knitter-switch

Product Change Notification

Change Of Welding Of Housing Parts

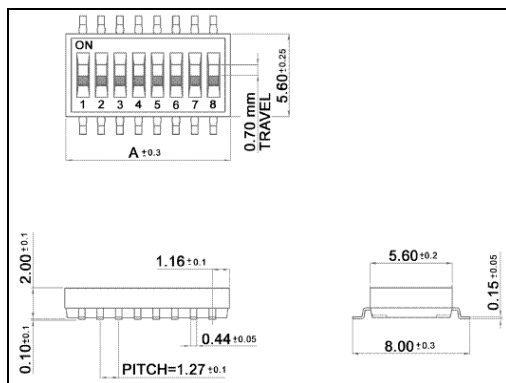
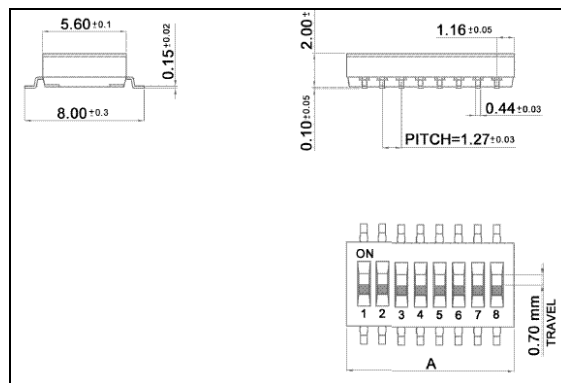
Up to now the lid was inserted into a cut-out of the base part and ultrasonic welded.

To increase the robustness the lid was now changed to an upper case part with same cross-section as the base.

Due to this, the welding line moves towards the side walls. This allows a more aligned and stable welding quality.
